# City of Corpus Christi

### Planning Commission

Wednesday, February 18, 2026

**TECHNICAL REVIEW PLAT REQUIREMENTS  
REGULAR PLANNING COMMISSION MEETING  
February 18, 2026**

## FINAL PLAT OF NEMEC TOWNE CENTER PHASE 2, BLOCK 1

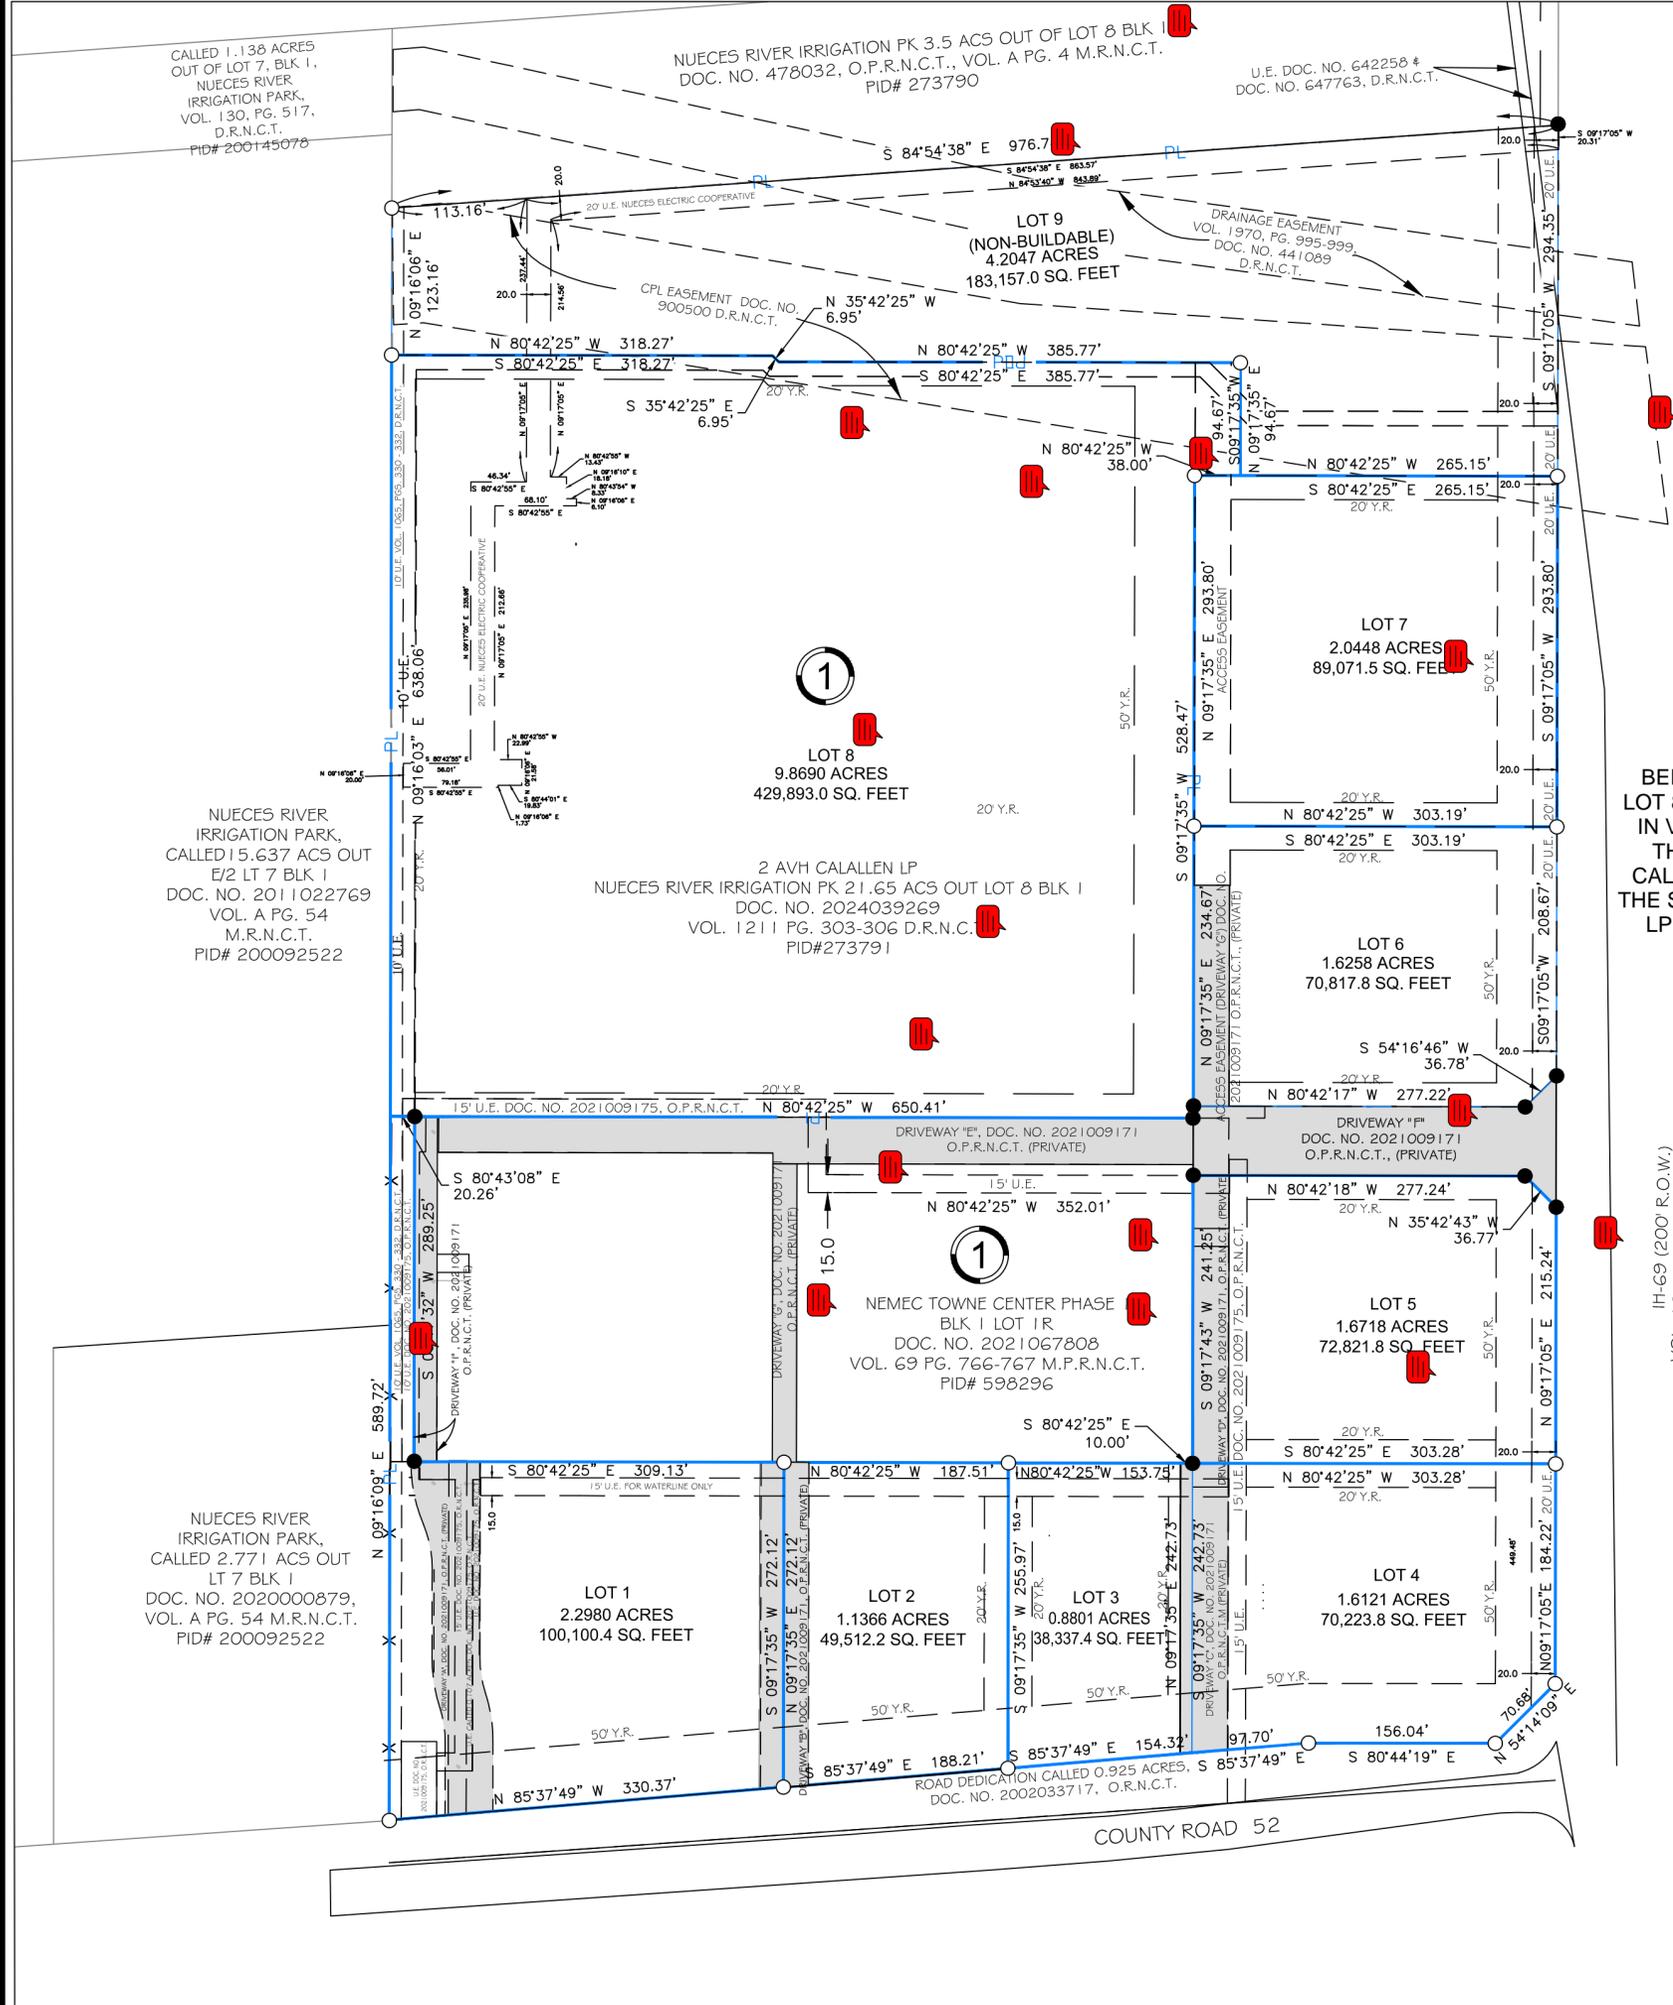
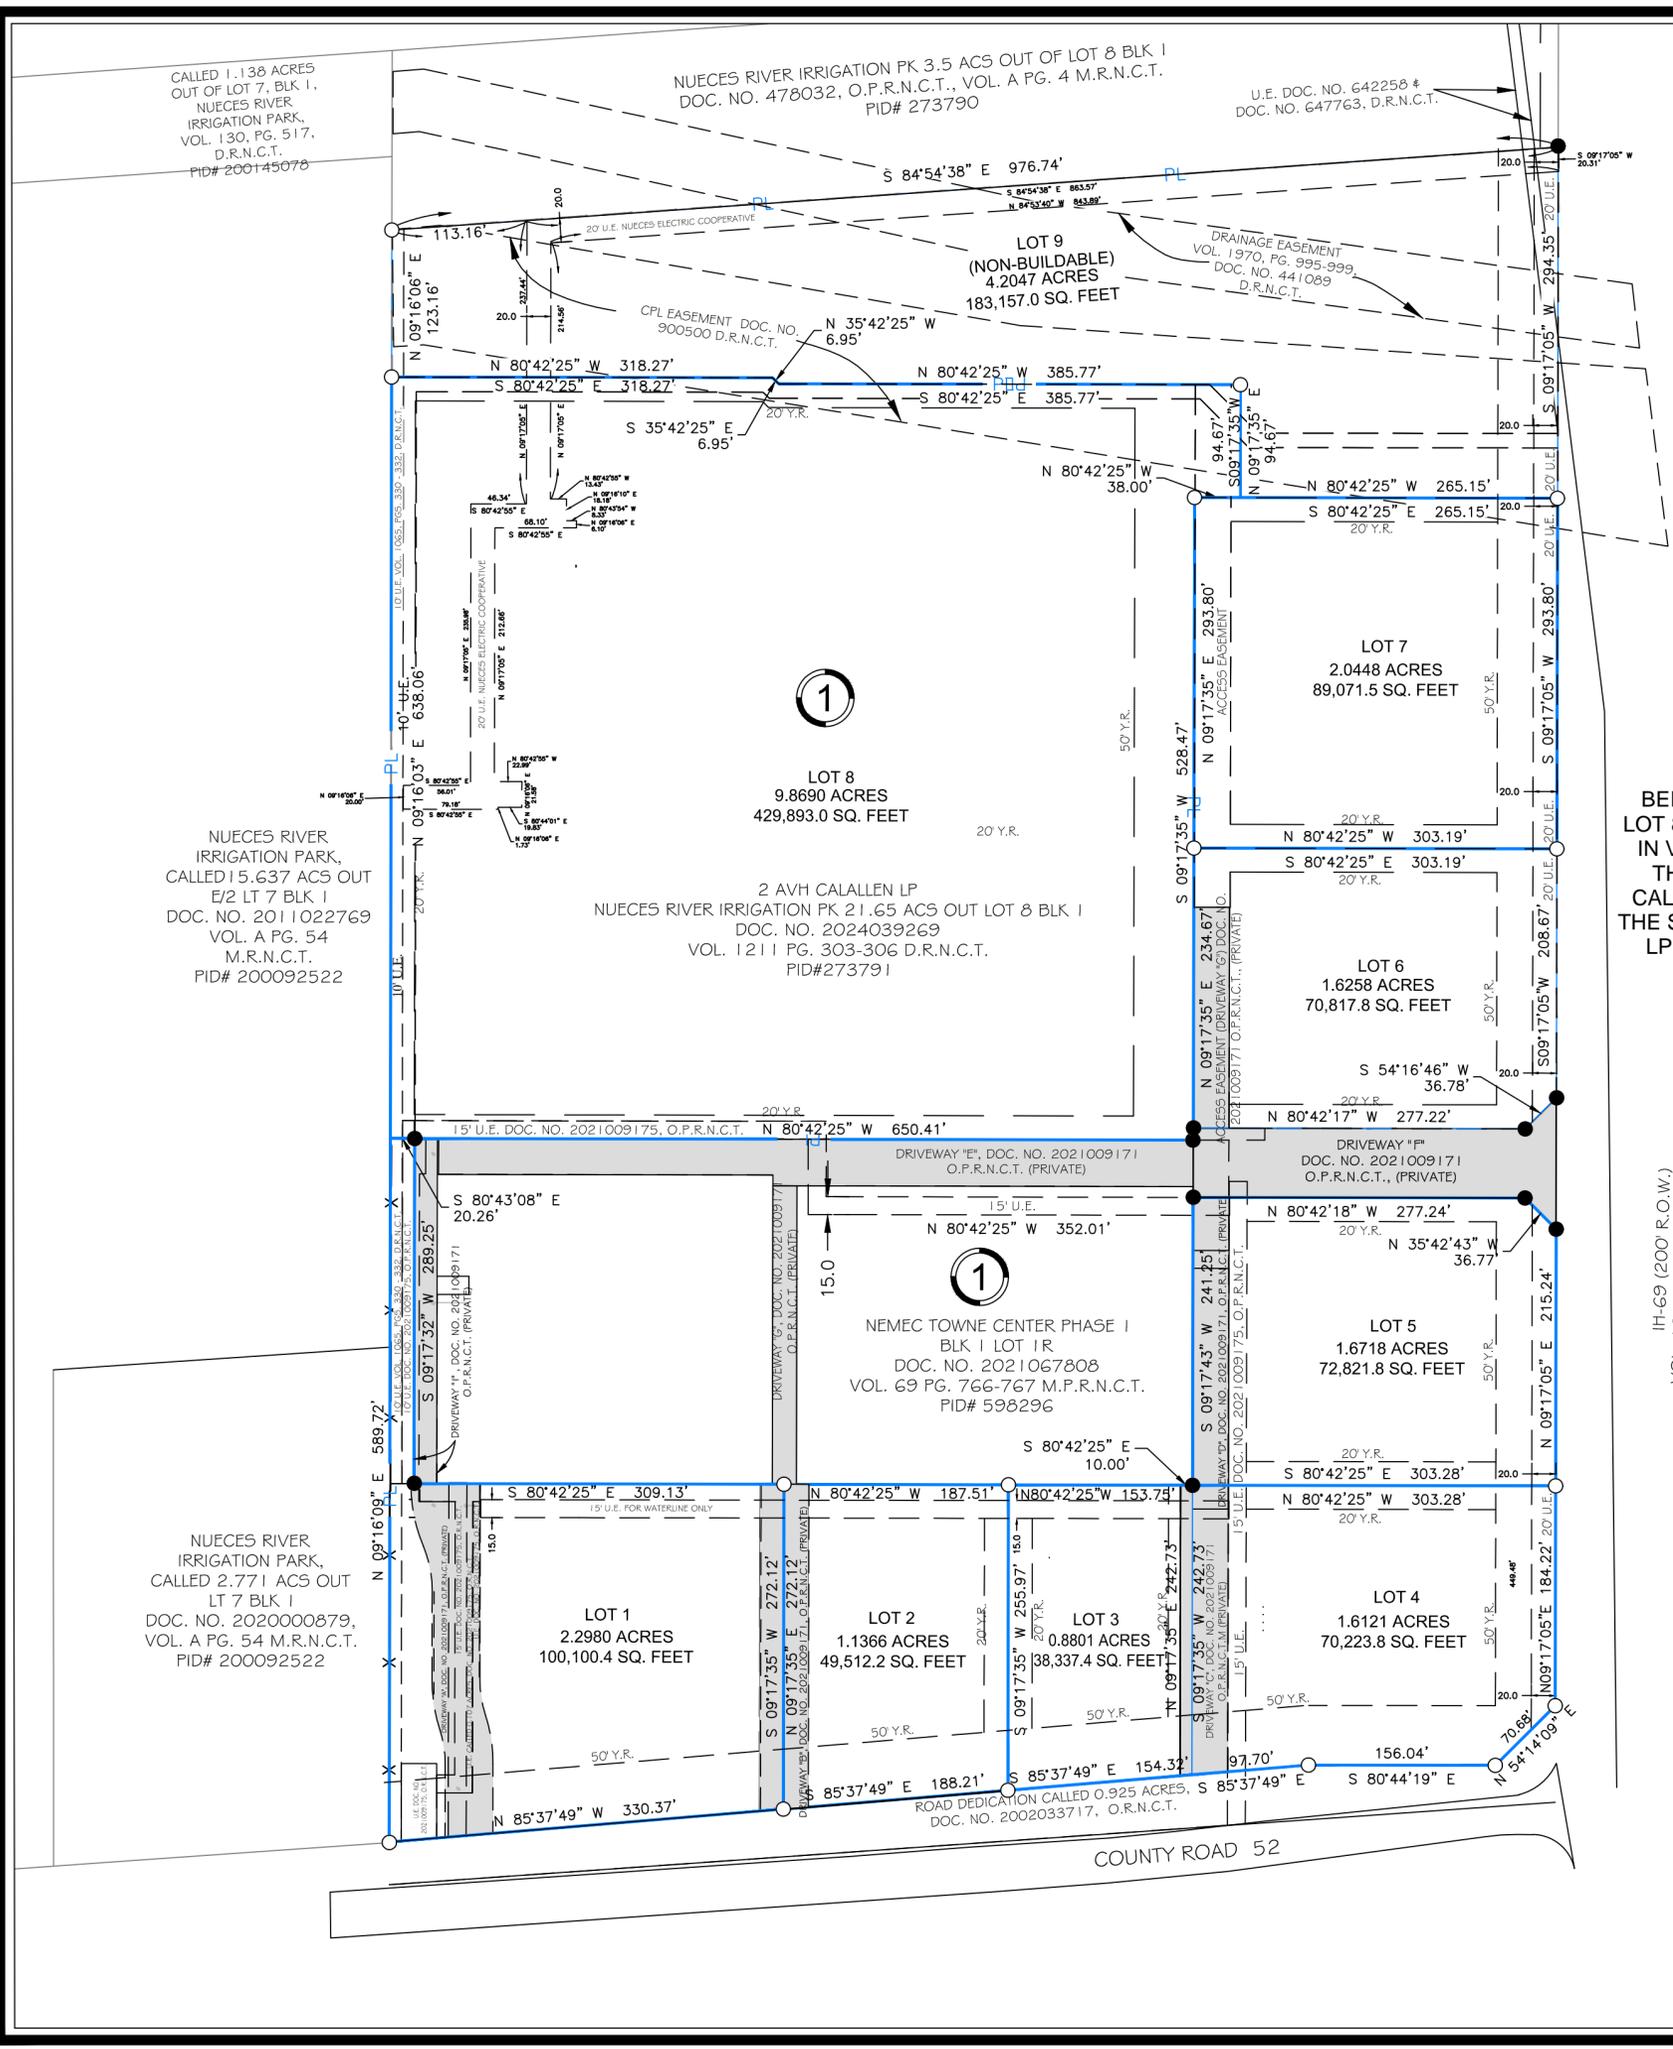
22	P002	Note	Mina Trinidad : DS	Closed	Include the yard requirement/zoning general note on the plat.	
23	P002	Note	Mina Trinidad : DS	Closed	Include the CG-2 General Commercial District yard requirements on the plat.	
24	P002	Note	Mina Trinidad : DS	Closed	Remove any existing structures shown on the plat.	
25	P002	Note	Mina Trinidad : DS	Closed	Will the existing street names remain? Ex: "Driveway E?" If streets are private, please label streets as private.	
26	P002	Note	Mina Trinidad : DS	Closed	Ensure all markings within plat are legible.	
27	P002	Note	Mina Trinidad : DS	Closed	(Informational) Streets: Public Works Streets does not have any comments.	
28	P002	Note	Mina Trinidad : DS	Closed	Revised scale of location map, focus more on the subject property and ensure all streets are legible surrounding the property.	
29	P002	Note	Mina Trinidad : DS	Closed	Write "non-buildable" under Lot 9 within the plat.

30	P002	Note	Mina Trinidad : DS	Closed	Remove the "Preliminary, this document shall not be recorded" verbiage from the plat.	
7	Utility Plan	Note	Mina Trinidad : DS	Closed	<p>Fire: (Captain Mark Lewis)</p> <p>12/9/25 Update: Mina, all Fire concerns have been addressed and Fire approves of PL9043 TRC 2 Nemec Towne Center Phase 2 (3601 IH 69).</p>
